U.S. GEOLOGICAL SURVEY  
RESEARCH REACTOR  
LICENSE NO. R-113  
DOCKET NO. 50-274

RESPONSE TO NRC STAFF REQUEST FOR  
ADDITIONAL INFORMATION  
FOR LICENSE RENEWAL REVIEW  
APRIL 1, 2016

Reference: U.S. Geological Survey TRIGA Reactor (GSTR), Docket 50-274, License R-113, Request for Additional Information (RAI) dated February 8, 2016

RAI dated 2/8/2016

Figures 1 and 2 show two of the three inverse multiplication curves for the loading of the USGS core. The one not shown gives a sizably lower multiplication until the last few loading steps.

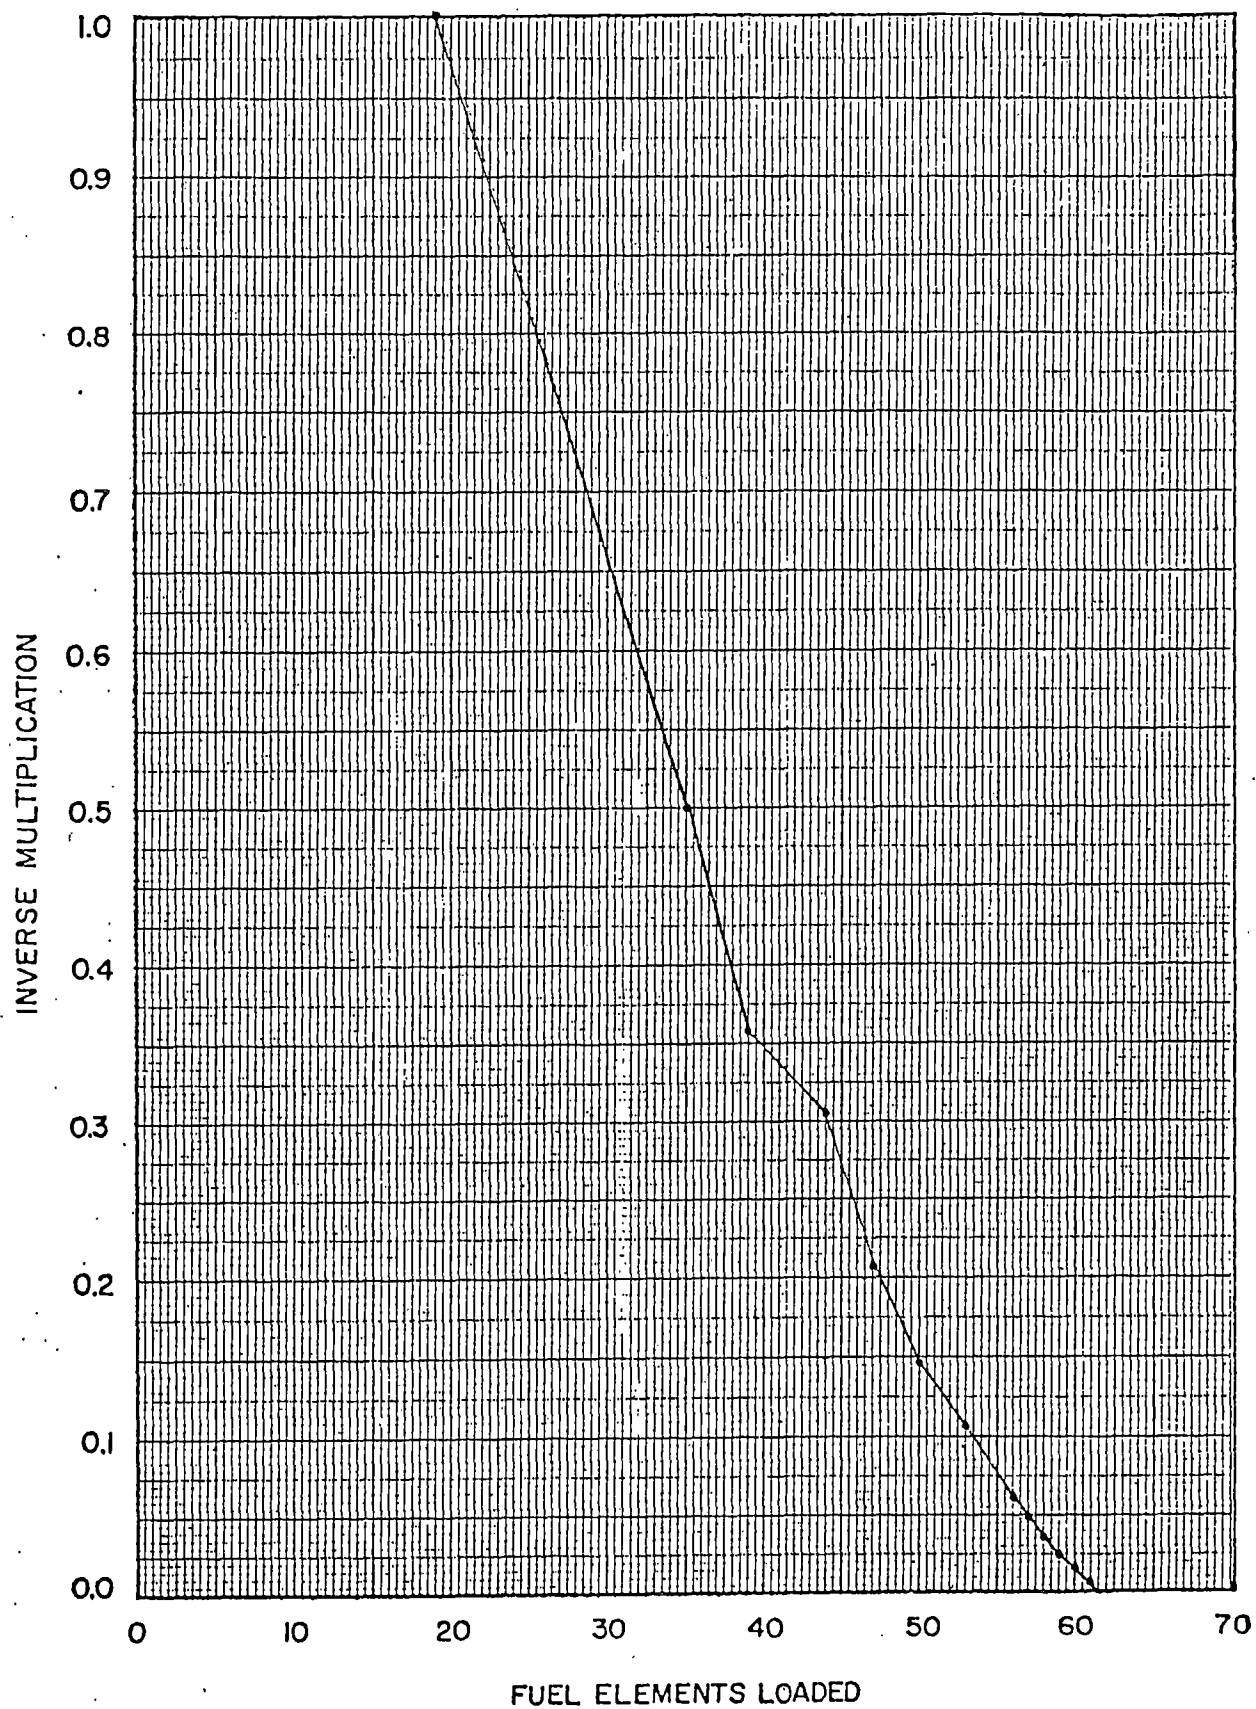
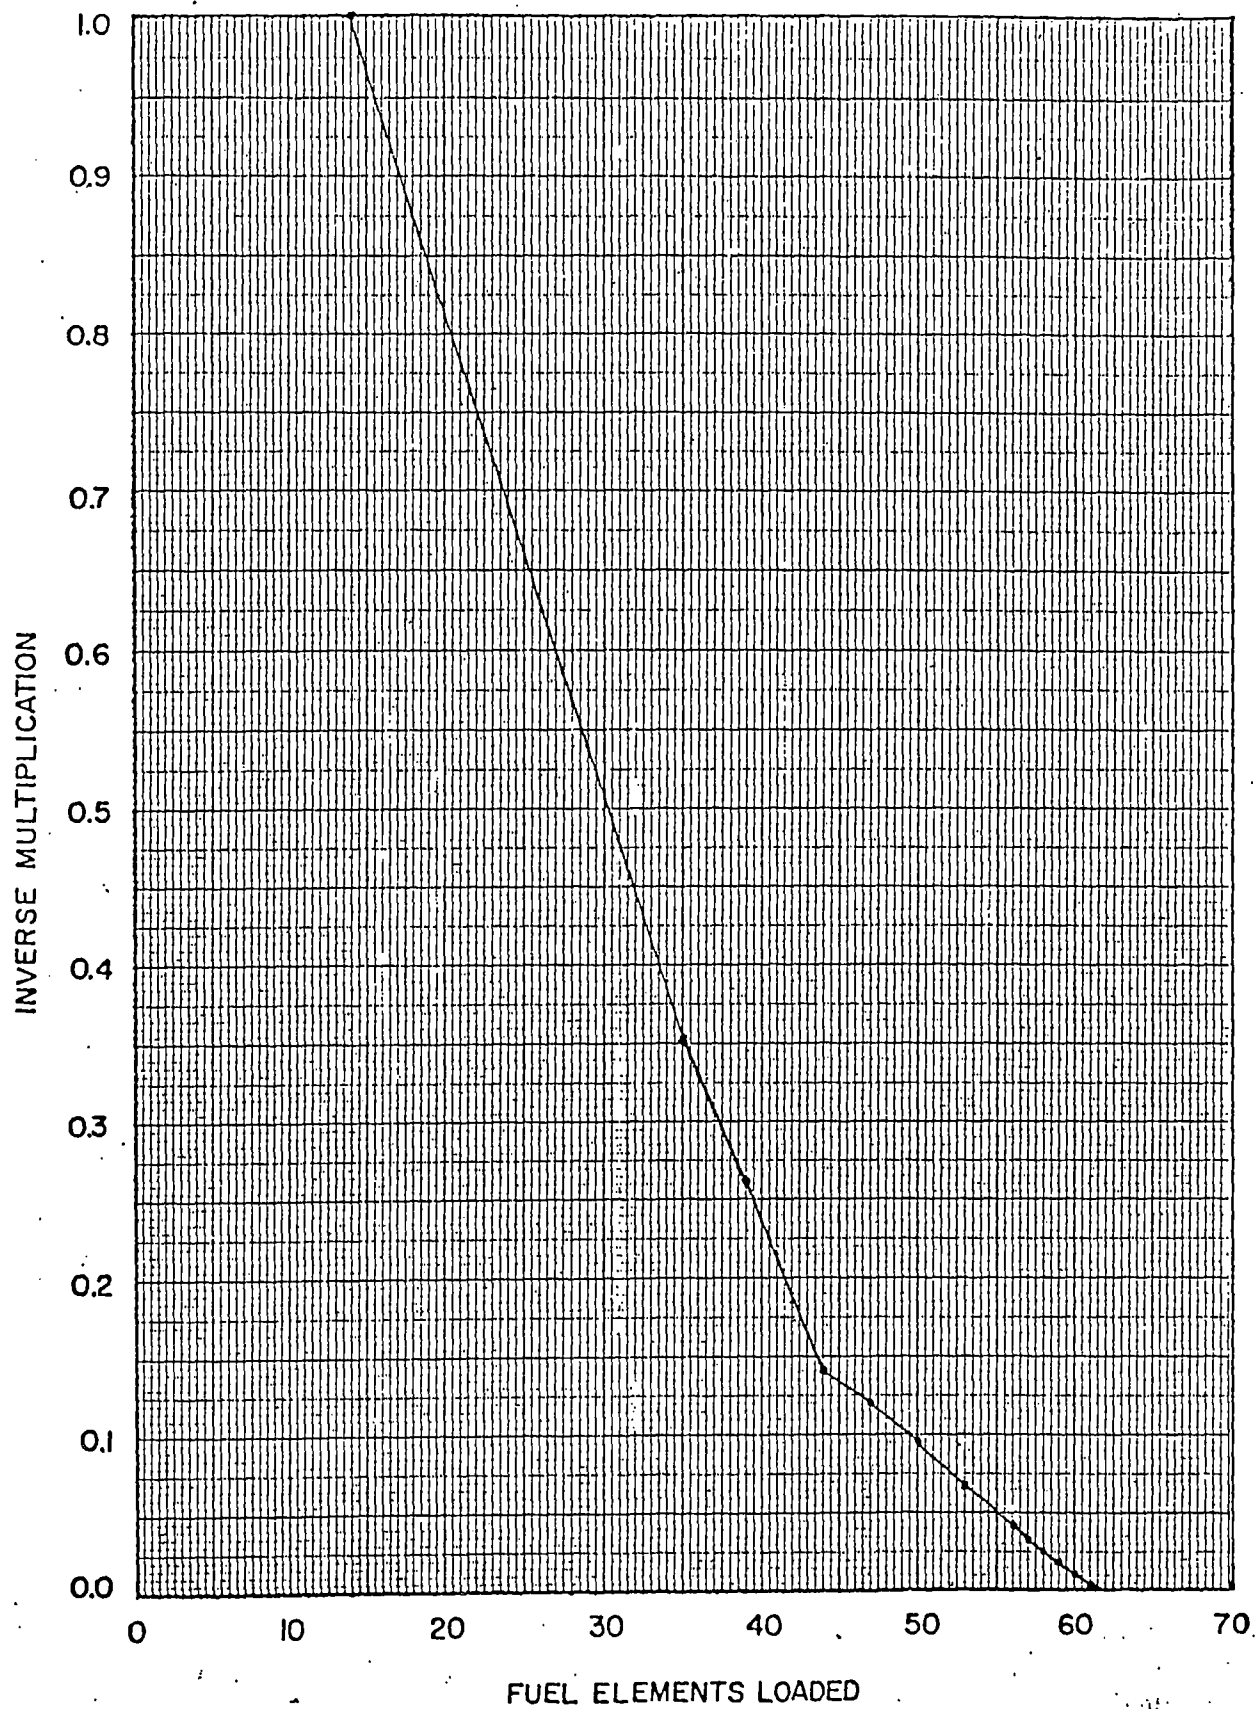
The USGS SAR, Section 9.2.1, "Fuel Storage Racks," provided information concerning the storage of the USGS TRIGA fuel, including a statement that the keff was measured to be below the limit of 0.9. However, it is not clear if this applies to racks located in both the in-tank and the fuel pit locations. NUREG-1537, Part 1, Section 9.2, "Handling and Storage of Reactor Fuel," provides guidance that the licensee should provide an analysis that shows that the keff for fuel storage, under all conditions, is less than 0.9. Provide an analysis or discussion that demonstrates that the fuel storage keff is less than 0.9 under all conditions, or justify why no explanation is needed.

The limiting configuration for fuel storage Keff is water-moderated hexagonal fuel racks that hold up to 19 fuel elements. At optimum spacing and water moderation, a TRIGA reactor needs approximately 54 fuel elements to achieve criticality. A criticality analysis performed by General Atomics (see attachment 1) that shows that the Keff in this 19-element rack is well below 0.8 in a worst case, water-moderated condition.

The critical approach loading curves for the USGS reactor can be used to demonstrate that the effective neutron multiplication factor (K effective) is less than 0.8 when the storage racks are full of TRIGA fuel containing 8.5 wt-% U (20% enriched), the storage wells are full of water and there is either a single storage rack or two storage racks stacked vertically in the storage well.

it is shown that approximately 42 to 47 fuel elements are necessary to give a  $K = 0.8$ . Checking the loading curves for a more recent, similar reactor produced similar results. Thus a flooded storage well with a fully loaded single storage rack, containing 19 fuel elements, clearly has a  $K$  less than 0.8. A flooded storage well with two fully loaded storage racks stacked vertically also clearly has a  $K$  less than 0.8, especially when the following items are considered:
